TECHNICAL DATA SHEET  
Petition # 2002-II2

DATE: June 12, 2014  
TO: Mark Fowler, Zoning Supervisor  
FROM: Debra Campbell, Planning Director

SUBJECT: Administrative Approval for Petition No. 2002-112 Portrait Homes  
Attached are the revised plans to allow single-family detached in tract C. Since this change does not alter the intent of the development and meets the requirements of the Charlotte Zoning Ordinance Section 6.207 Alterations to Approval, minor changes, I am administratively approving this plan. Please use these plans when evaluating requests for building permits and certificates of occupancy.

**MERRYHUE FARMS**

**SCHEMATIC SITE PLAN**  
Petition #2002-II2

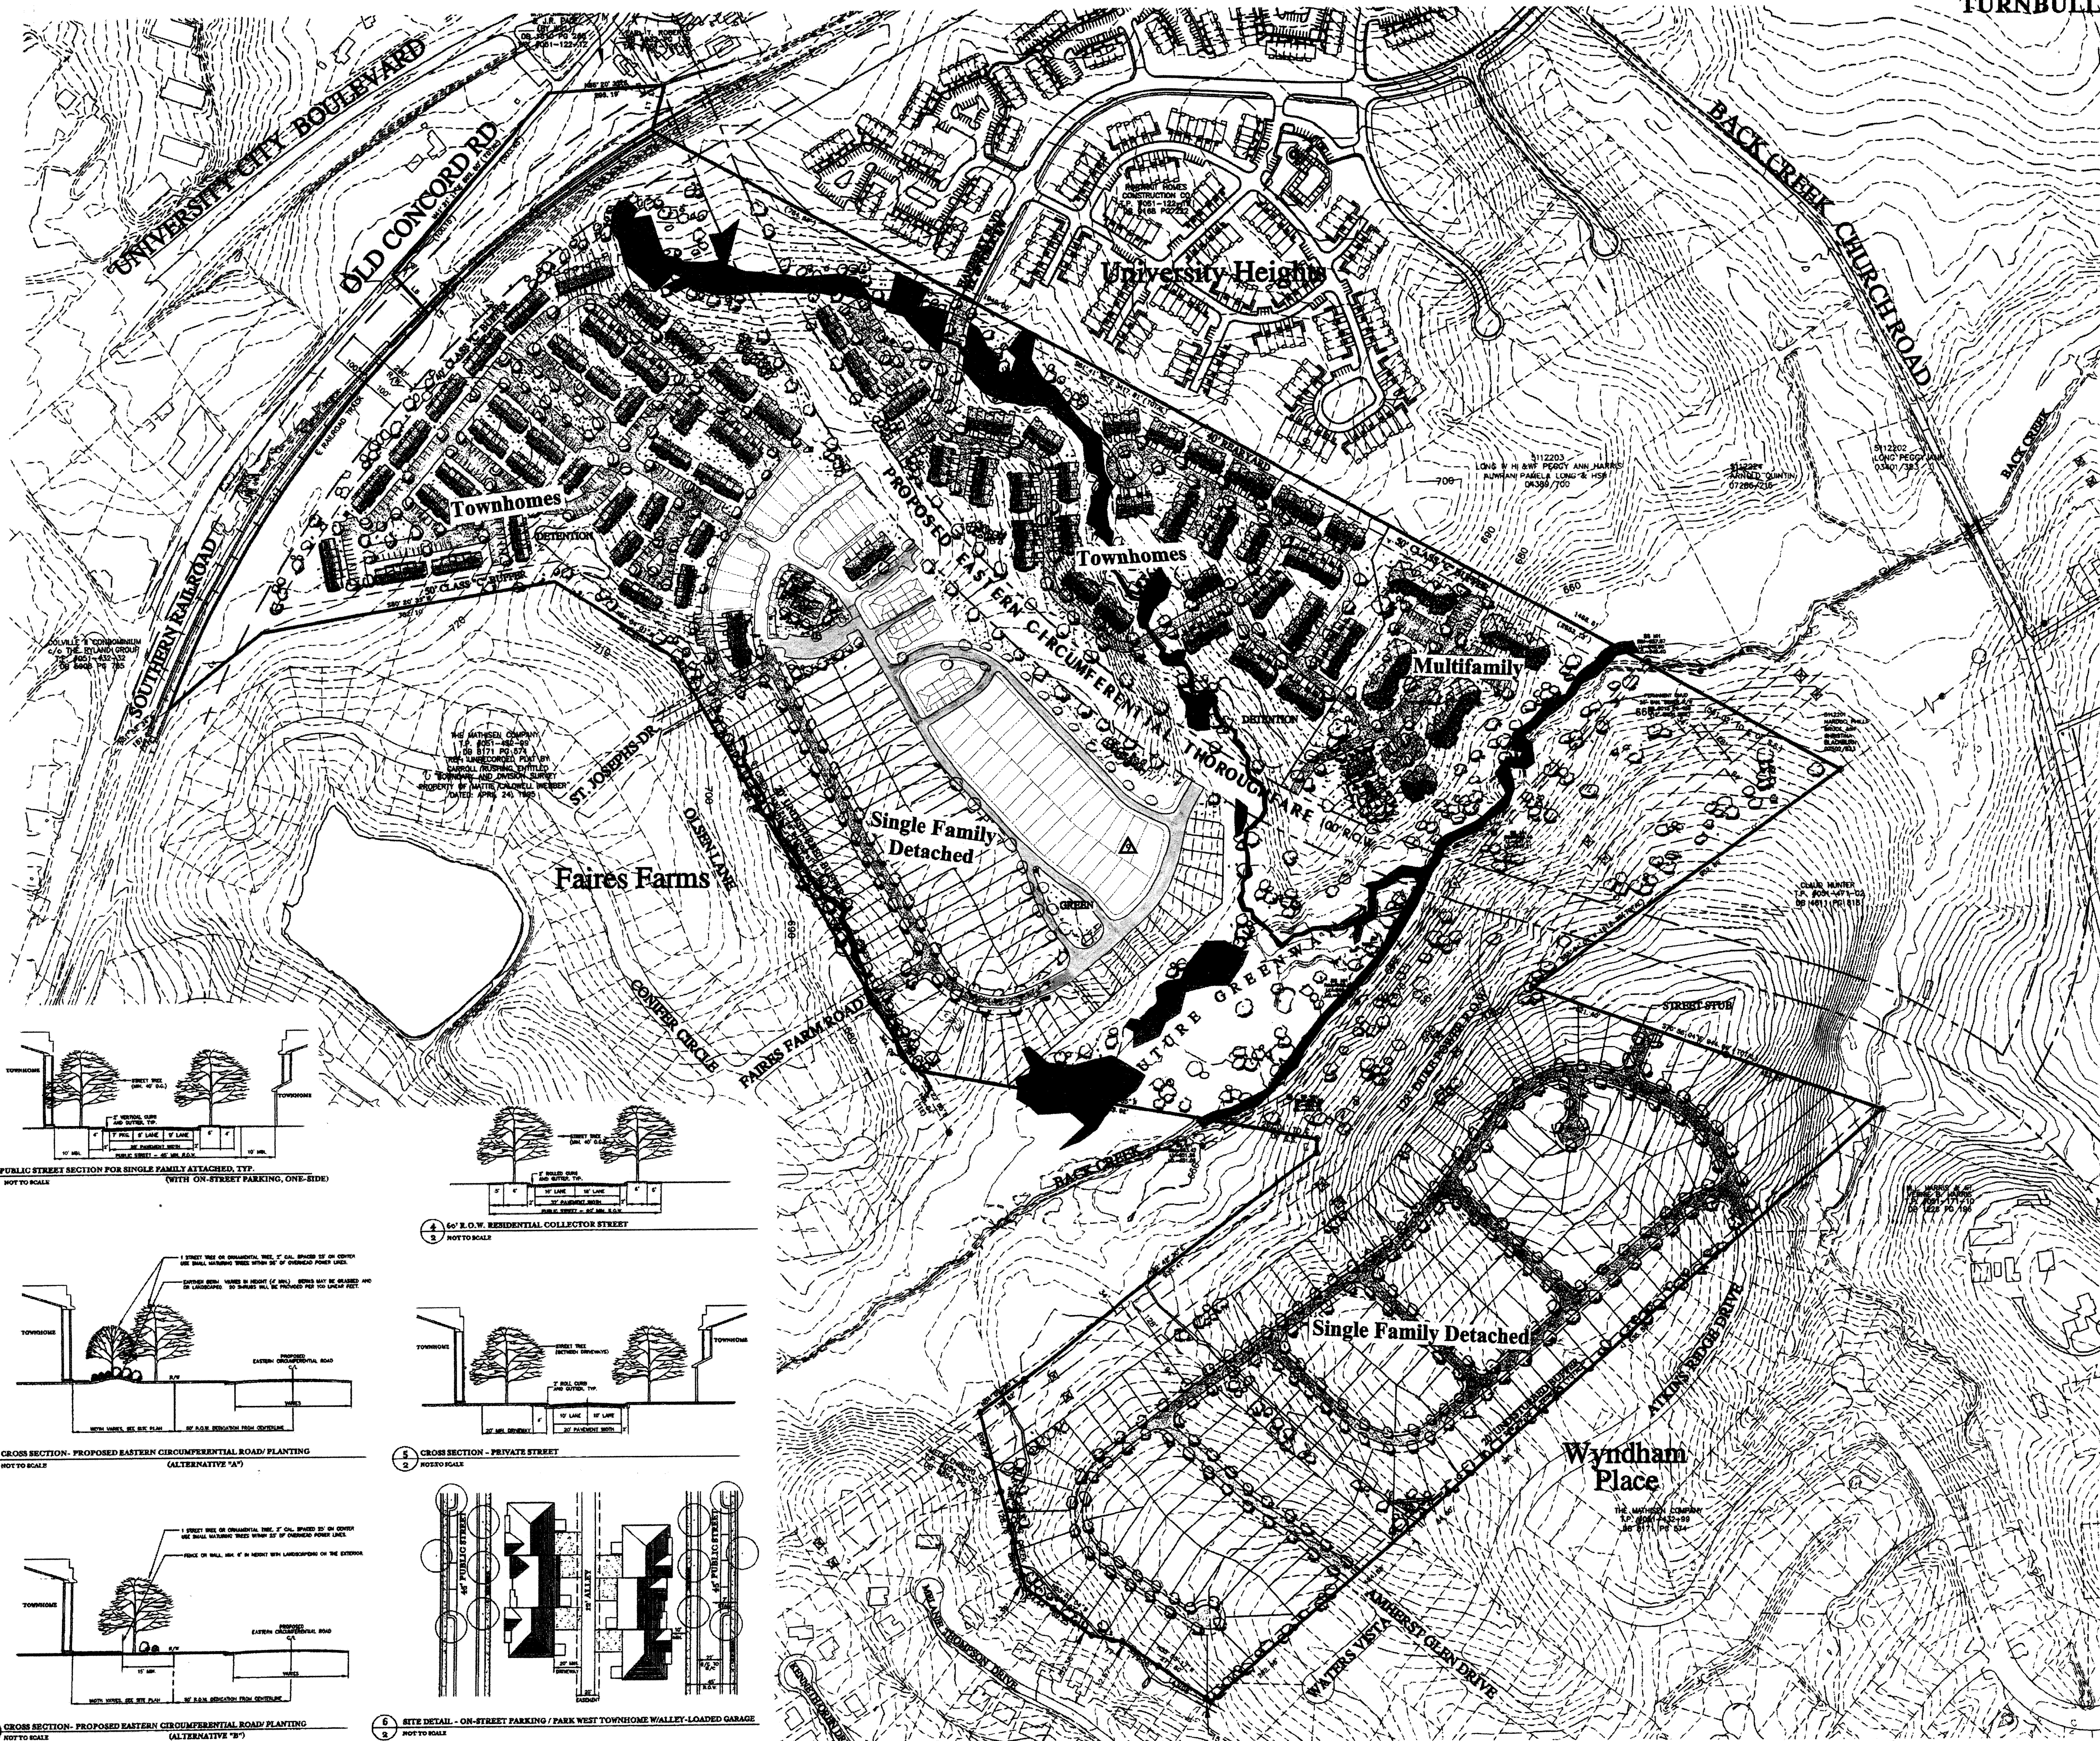
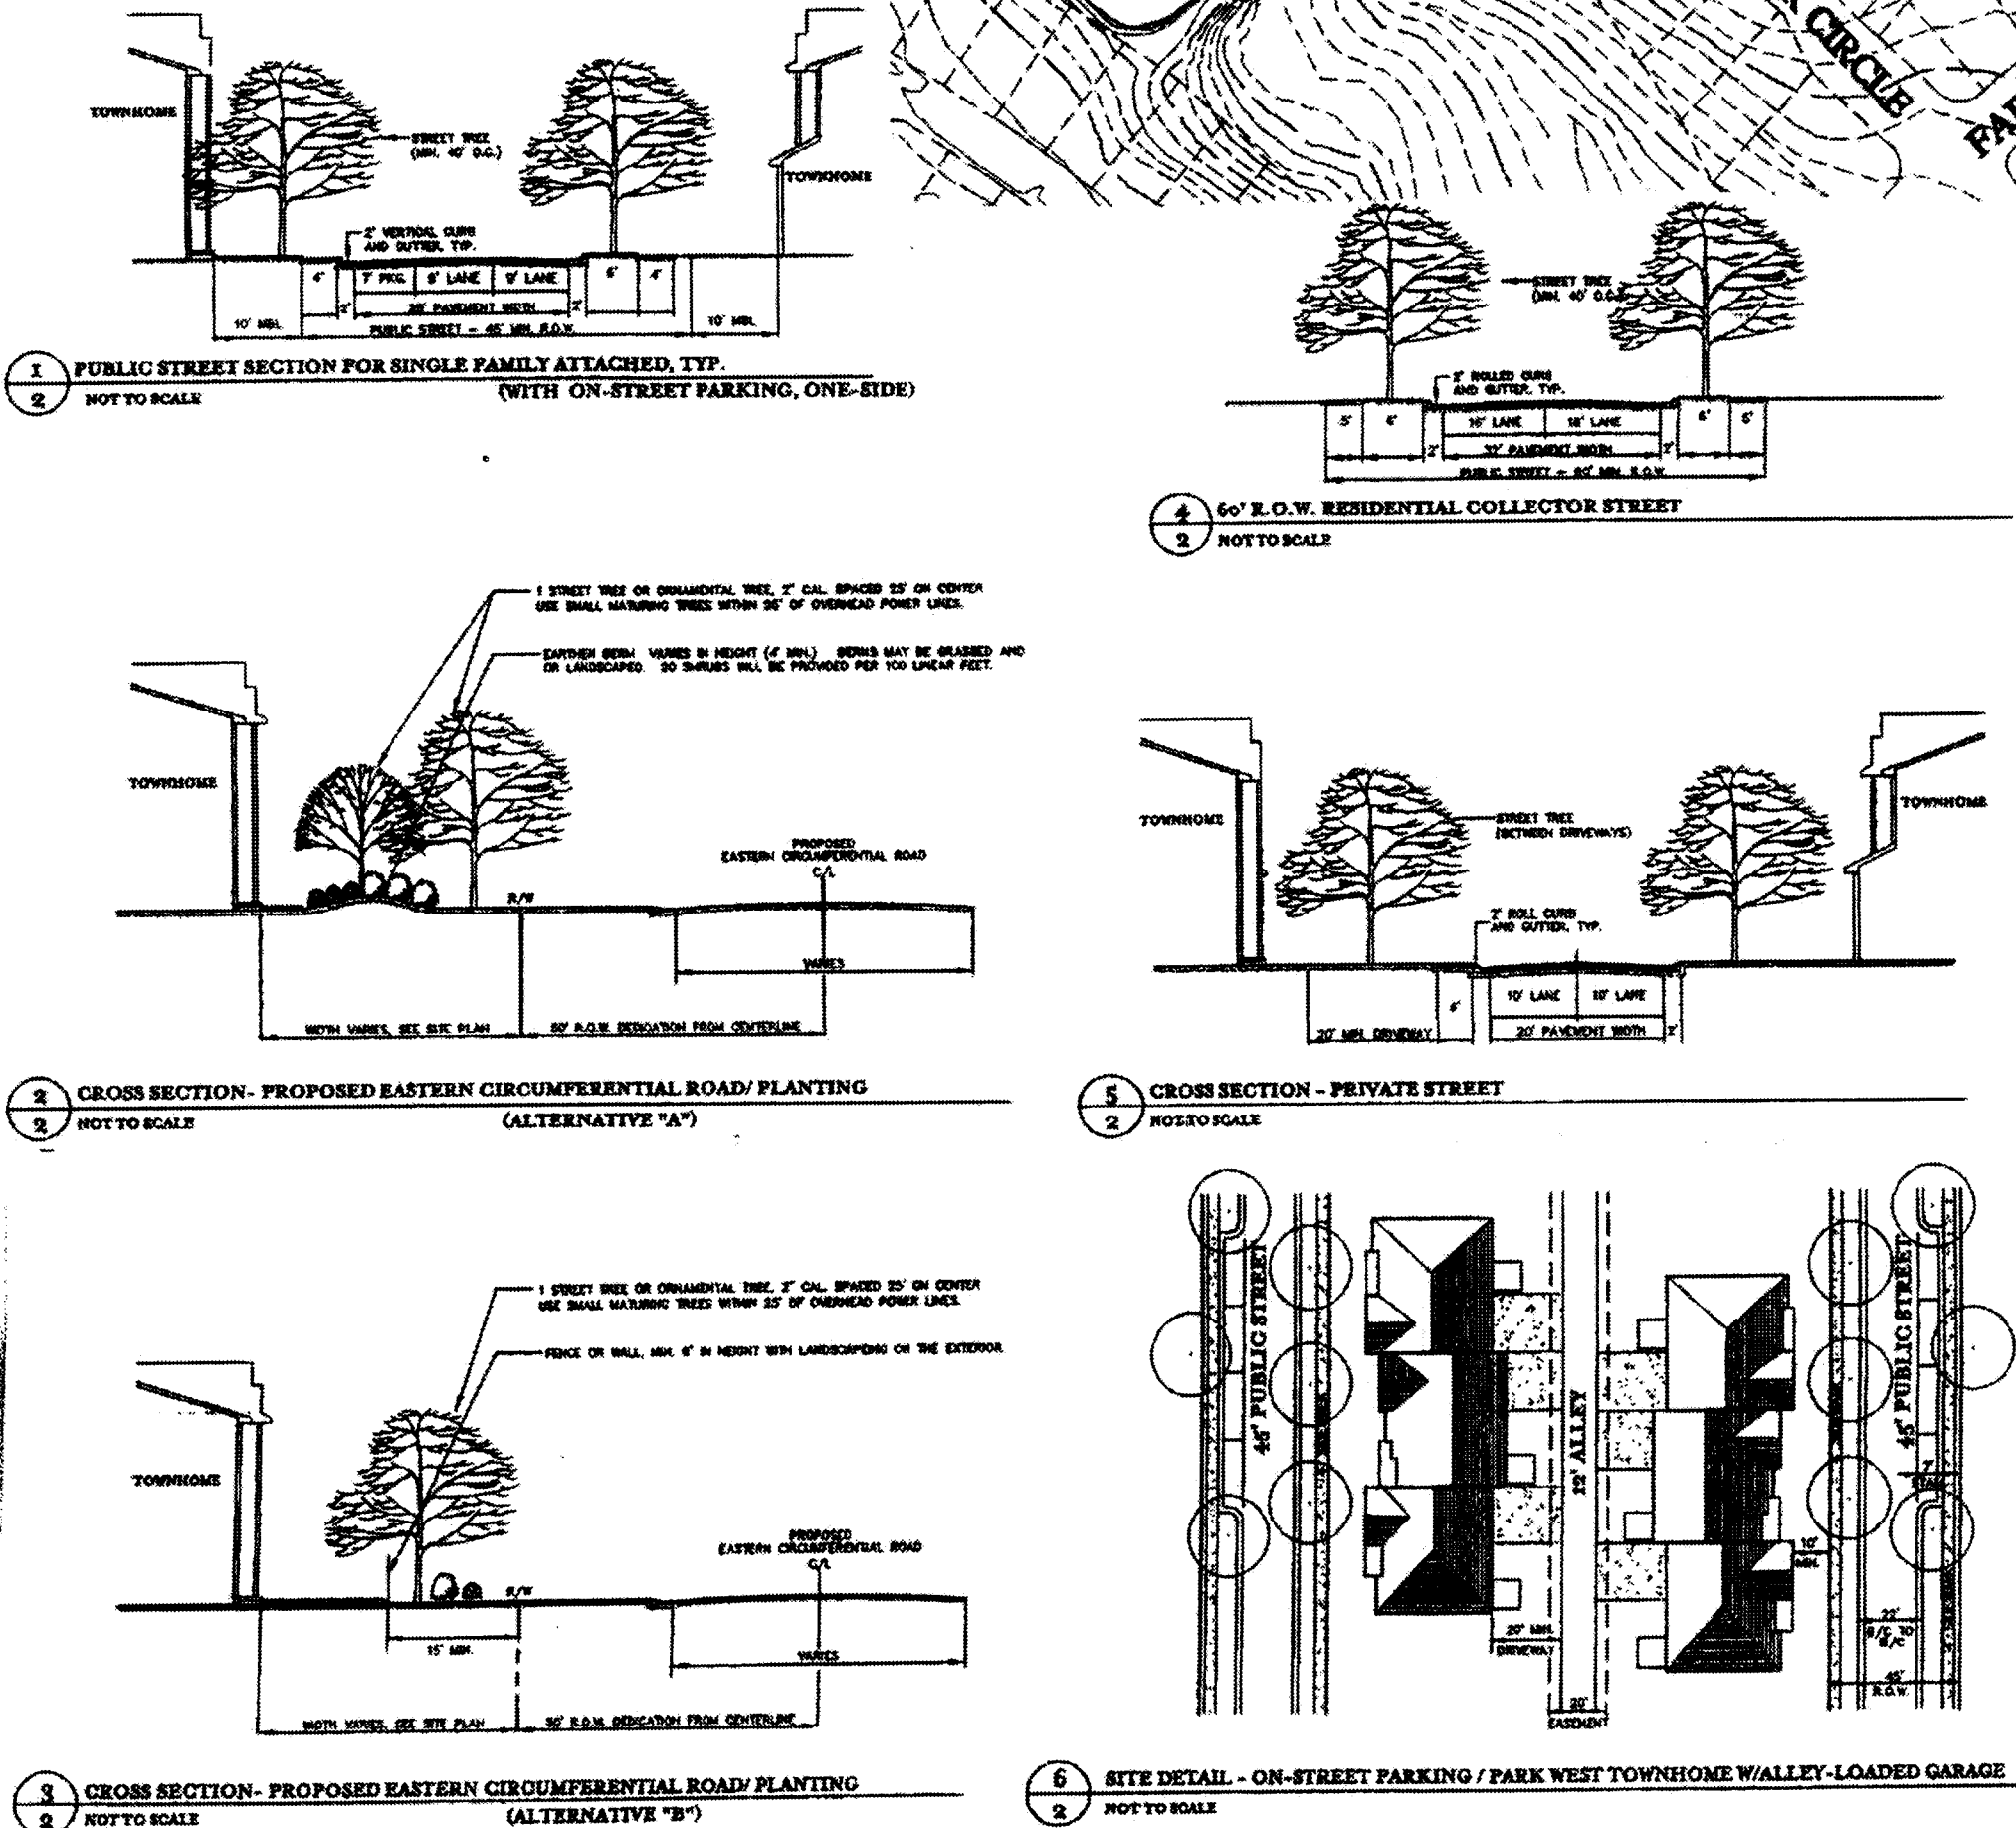
Reasons for Staff's support of the request:  
• The proposed lots are consistent with the single-family lots approved in adjacent tracts included in this rezoning.
